**From:** Dunn, John [<mailto:Dunn.John@epa.gov>]  
**Sent:** Wednesday, December 04, 2019 9:41 AM  
**To:** Hackler, Pam <[pam.hackler@dnr.mo.gov](mailto:pam.hackler@dnr.mo.gov)>  
**Cc:** Wieberg, Chris <[chris.wieberg@dnr.mo.gov](mailto:chris.wieberg@dnr.mo.gov)>; Michael Abbott - MDNR <[michael.abbott@dnr.mo.gov](mailto:michael.abbott@dnr.mo.gov)>;  
[heather.peters@dnr.mo.gov](mailto:heather.peters@dnr.mo.gov); karen\_herrington@fws.gov; Jennifer Campbell <[Jennifer.Campbell@mdc.mo.gov](mailto:Jennifer.Campbell@mdc.mo.gov)>;  
Madden, Venessa <[Madden.Venessa@epa.gov](mailto:Madden.Venessa@epa.gov)>; Curtis, Glenn <[curtis.glenn@epa.gov](mailto:curtis.glenn@epa.gov)>  
**Subject:** Comments on Ameren Labadie 316(a) Variance Request

EPA has two sets of comments on the proposed variance. Comments on the Biological Study are attached, and NPDES permit based comments are below:

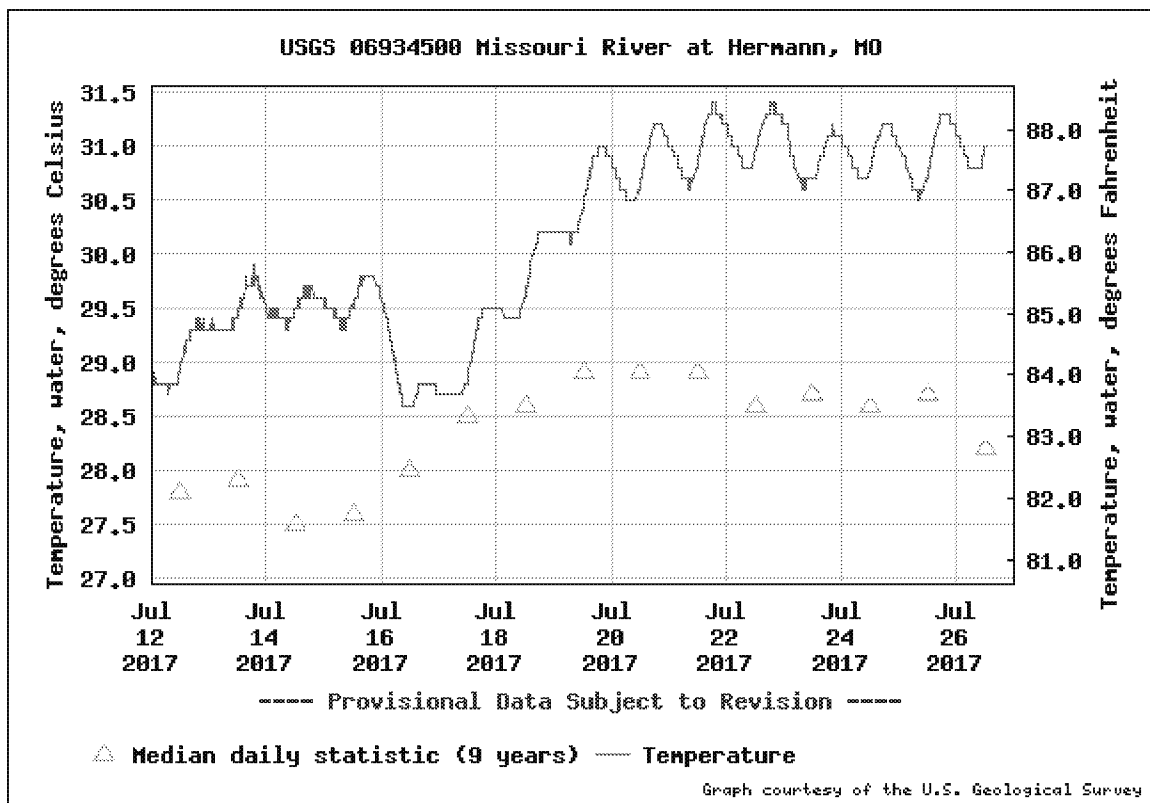
Equations for deriving TDP are calculated to many significant digits but monitoring in the current permit is only required once daily. During heat events, stream temperature can vary by up to 1.5°F in a given day. See 2017 data in the graph below.

The permit should assure that monitoring precision matches up with the detailed nature of the modeling. It should be noted that the USGS gage at Hermann, the data source for the permit, monitors Flow and Temperature every 15 minutes. Temperature can be measured inexpensively by calibrated thermistors feeding data to a computer that calculates TDP and estimated temperature at the edge of the RMZ. Continuous monitoring at this frequency would generate unneeded data, but high frequency monitoring when variance conditions are approached could create important data sets for future consideration. In any case, all data used in the model equations should be time synchronized.
